## Environmental Planning Commission

Agenda Number: 3  
Project #: 2020-003658  
SI-2020-00356, 00357  
Hearing Date: July 9, 2020

### Staff Report

<b>Agent</b>	Consensus Planning, Inc.
<b>Applicant</b>	Greystar
<b>Request</b>	1) Major Amendment to Site Plan –EPC 2) Site Plan -EPC for development of a 171-unit age-restricted, senior housing development.
<b>Legal Description</b>	Tracts 1-6 North Andalucia at La Luz Tract 4 North Andalucia at La Luz
<b>Location</b>	SE corner of Coors Blvd. NW and Montano Rd.
<b>Size</b>	Approximately 60 acres
<b>Zoning</b>	PD

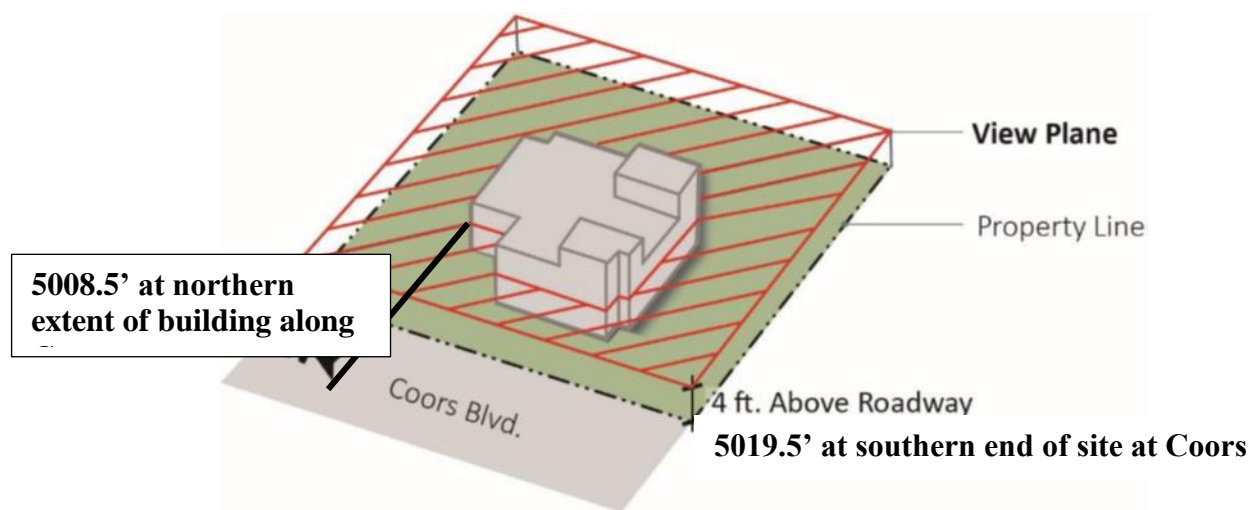
- 3-6(D)(5)(a) No more than 1/3 of the height of structures (including building parapets, mechanical equipment and associated screening, walls, and fences) shall be allowed to penetrate above the view plane as shown in section diagram below. On lots with developable area that is constrained because the natural grade (or finished grade, if infrastructure is already installed) is less than or equal to 10 feet below the elevation of the east edge of Coors Boulevard and may also include sensitive lands (see Subsection 14-16-5-2(C)), a total height of 16 feet for low-density residential and 20 feet for other uses is allowed (see figure below).

*The elevation of Coors Blvd. is 5015.5' with the 4-foot view plane falling at 5019.5'. The elevations of the main building are finished floor at 4992.5' and top of parapet at 5028.0'.*

**Height above View Plane: 8.5'**  
**Total Building Height: 36.5'**  
**One Third of Structure Height would be 13.16'**

$$8.5' \leq 13.16'$$

**Resulting location of site line**

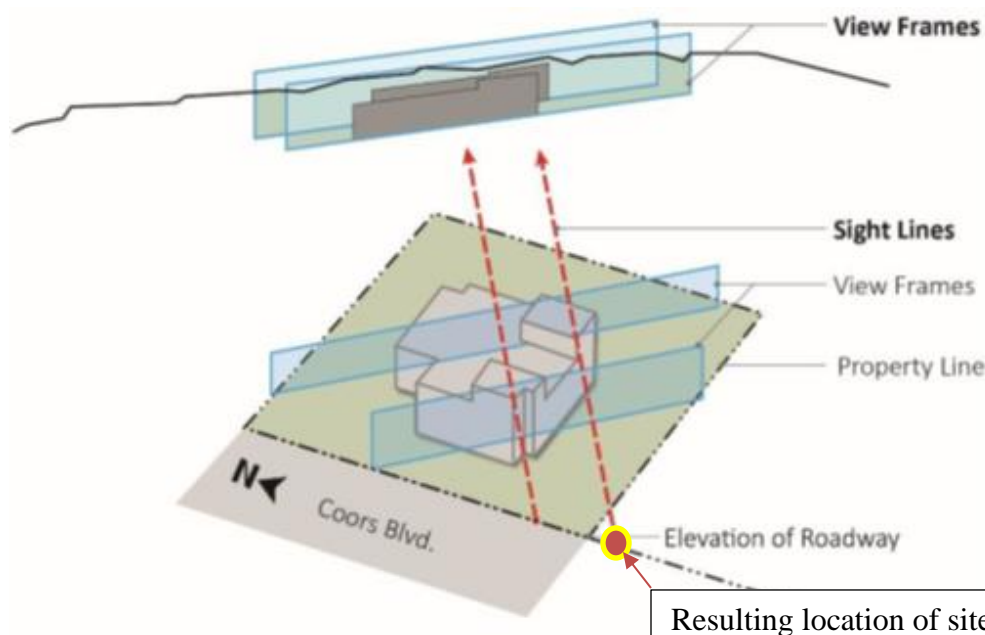
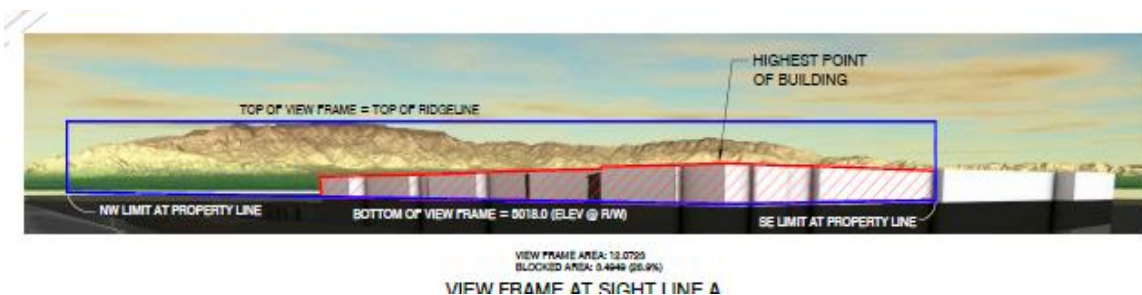
*The proposed building, is essentially a steady 35'-6" to the top of the parapet with little undulation. The highest point of the elevation is at 39'-0" along the eastern elevation. The*

*placement of the view frame above is determined by establishing a site line that runs from the Coors right-of-way at a 45-degree angle towards the Sandia Mountains and passing through the highest point of the building, thus showing the greatest obstruction caused by the building. That resulting location was approximately 70 feet to the south of the site.*

*Previous building locations produced more impacting view planes. The latest building location results in a view field of less than 50 % coverage of the view and not crossing over the Sandia ridge line from the locations set out by the VPO ordinance.*

*A second View Frame along site line B was presented to neighborhood groups but caused more confusion. Rather than following the view at a 45-degree angle northeastwardly, the site line B was looking at the project from the northern corner toward the southeast. This created a false sense of what view was to be protected. Subsequent view fields show that the proposed building does, in fact fall within acceptable parameters.*

### **Revised Site Plan and View Frame (4/15/2020)**

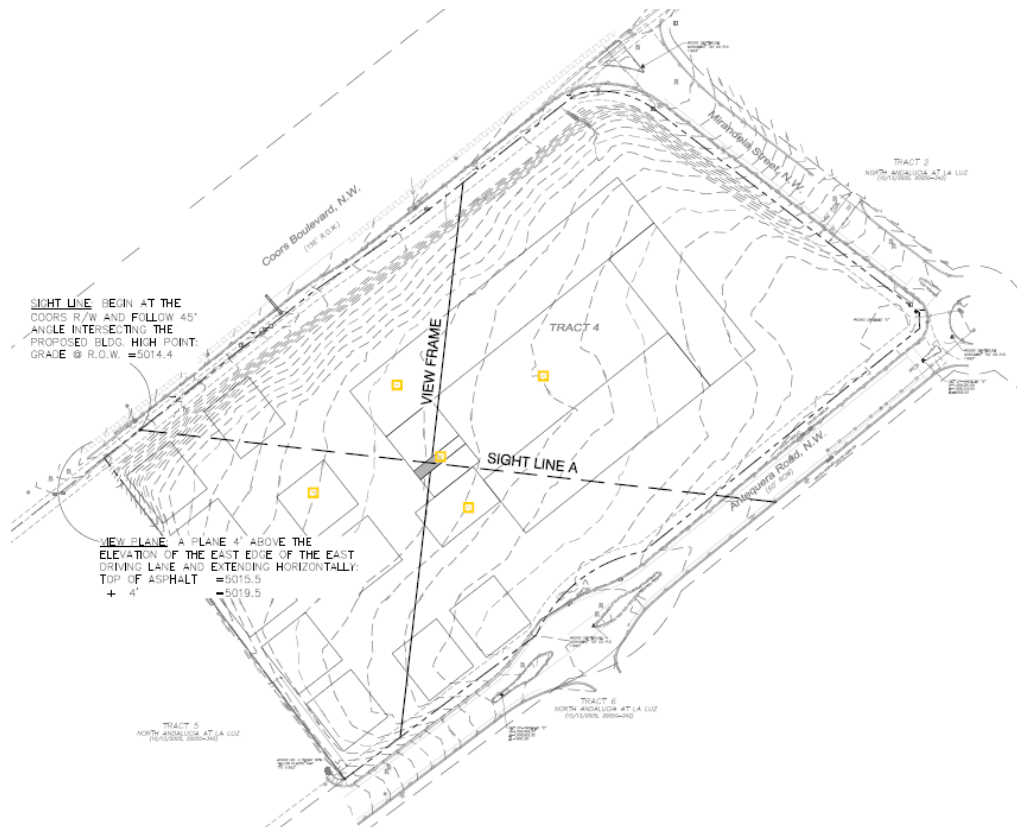
Code Enforcement and Long Range Planning reviewed two early drafts of the site plan for compliance with the Coors View Protection Overlay regulations in the IDO, specifically Subsection 3-6(D)(5) height, bulk, and massing. There were two internal meetings, the first on Friday April 10, 2020. During that meeting the site plan (which has since been revised) was reviewed by the team. After review, the team asked the agent to provide more information pertaining to the structures and their heights. We also asked the agent to ensure the proper placement of the camera in the view frame rendering to allow proper for proper analysis.

After the initial internal meeting with Code Enforcement and Long Range Planning, the agent provided a drawing that had more information, shown below. The drawing included

building/structure types and heights and called out the highest point of the building in red. In that iteration of the site plan, the high point (39') of the building was located on the southwest portion of the building, the 3-story building was located on the northern portion of the site, and the cottages were on the southern end. The camera placement for the view frame rendering was also changed to be 4 feet above the elevation of Coors Blvd. (the sight line elevation), which resulted in a less obstructive of the view of the Sandia's (shown below). Although the building took up a higher percentage of the view frame (48.4%), the rendering showed the building to obstruct less of the view of the east, including views of the bosque, the city, and the mountains. The southern end of the mountains and the bosque were completely visible in this view frame because the cottages were located on the southern end of the site; however, more of the view would be obstructed farther north where the bulk of the 3-story building is closer to Coors Blvd. Because there is only one high point to this building, only one sight line is required and only one was provided.

### Application Site Plan and View Frame (5/28/2020)

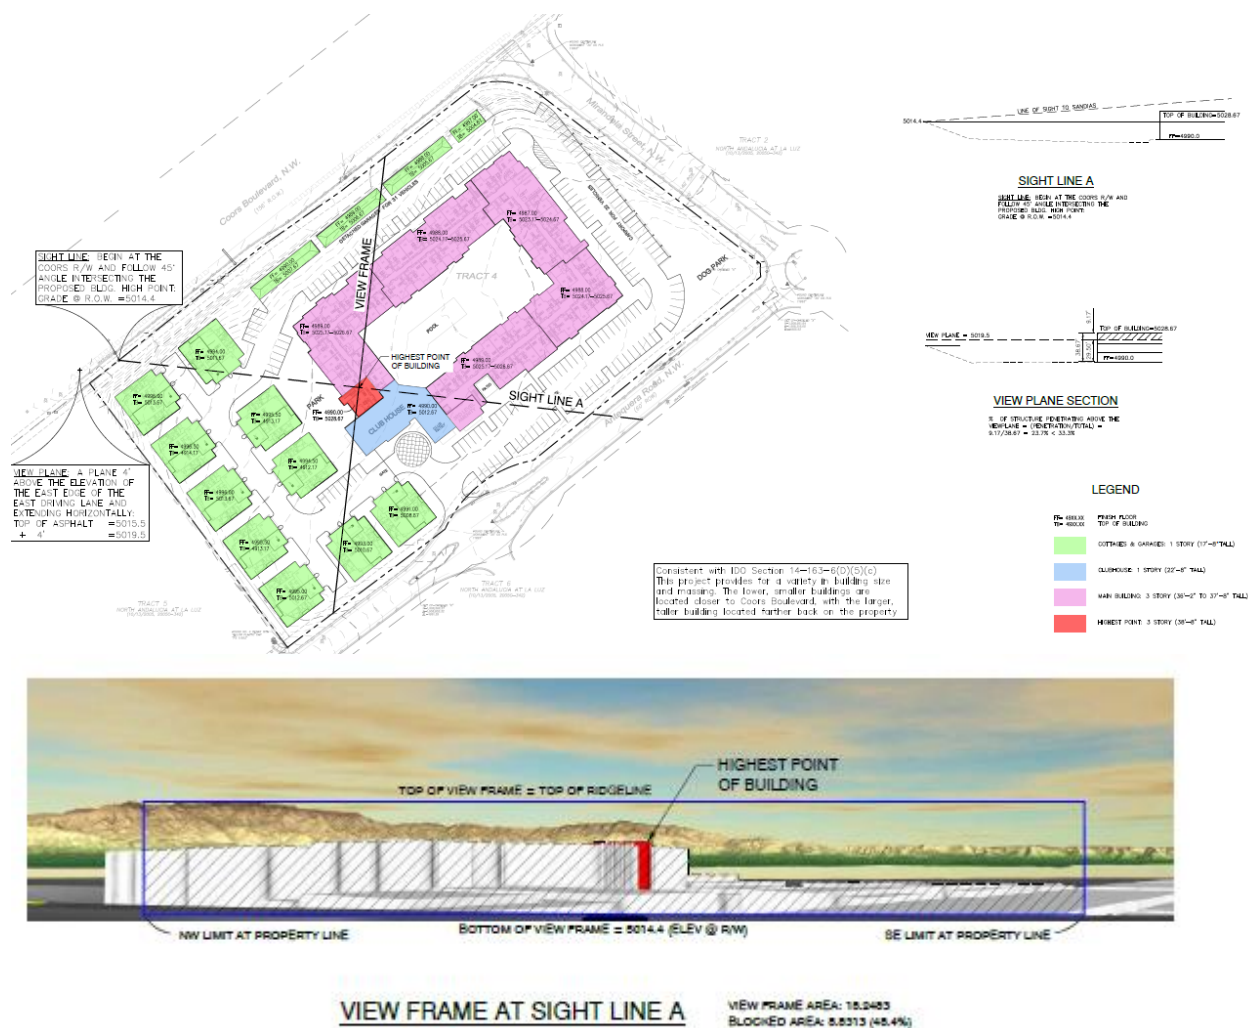
The most recent site plan and view frame analysis are shown below. The applicant made several adjustments to the site and considered the feedback from the City and from residents who participated in the required Neighborhood Meeting. The larger, taller building was moved as far back from Coors Boulevard as possible. The high point of the 3-story building was shifted away from the southwest to the south east of the site. These changes made a noticeable difference in the view frame analysis. The blocked area in the revised view frame is 39.3% as opposed to the 48.4% of the previous version. Because the tallest building is shifted further away from Coors Blvd., the massing of the building will appear to be smaller than in the earlier site layout; however, due to the location of the sight line, this view frame appears to have the building in a more prominent position. If a second view frame were created further north along Coors, then the view would open up where the cottage dwellings are located, revealing substantially unobstructed views of the northern portion of the mountains and bosque above the cottages. At no point does the proposed building penetrate above the ridgeline of the Sandia Mountains, which was a regulation under the Coors Corridor Plan.
